PHASE I REPORT
NATIONAL DAM INSPECTION PROGRAM

Name of Dam: WALKER LAKE DAM
State & State No.: PENNSYLVANIA, 52-127
County: PIKE
Stream: WALKER CREEK
Date of Inspection: April 3, 1980

WALKER LAKE DAM

NDI-ID No. PA-00317,
DER-ID No. 52-127

SPILLWAY APRON - NO. 7

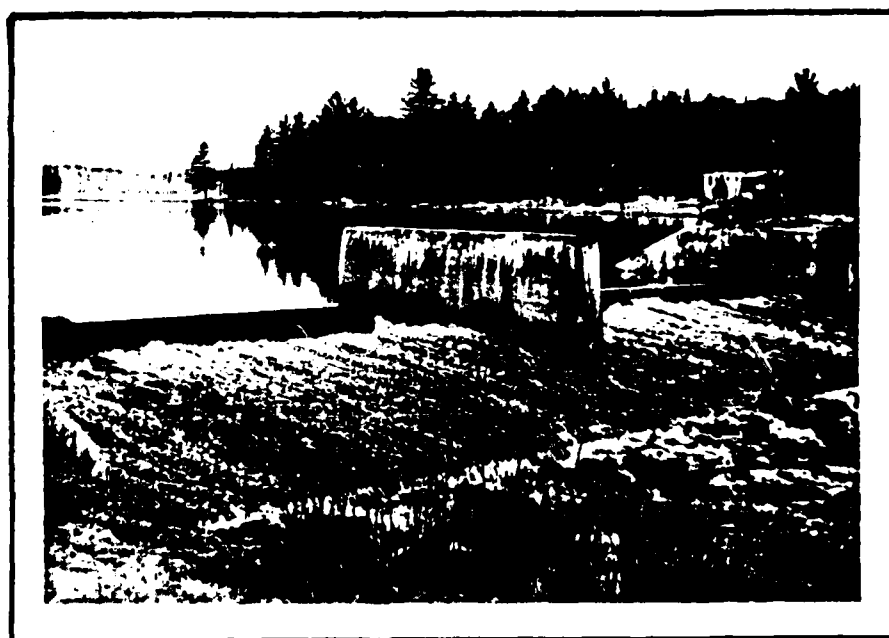
The apron immediately downstream of the spillway has been constructed with grouted handlaid stone. Several cracks and holes have formed in this apron. The immediate streambed below the apron is protected with loose riprap. The concrete of the ogee section and spillway walls show signs of deterioration (Photographs No. 5 and No. 7).

The spillway weir, downstream apron and spillway walls show signs of some deterioration. Holes and cracks in the apron should be repaired to prevent serious damage. Maintenance on the walls and weir is recommended at this time to prevent further deterioration and more costly repairs at a later date. The walls appeared to be stable at the time of inspection. There were no signs of tilting or unusual movement.

1. That the headwall on the outlet pipe be replaced and that holes and cracks in the spillway weir and apron be repaired.
2. That the gate on the outlet pipe be maintained and operated at least once a year.
3. That all brush and high weeds be removed from the embankment on an annual basis.
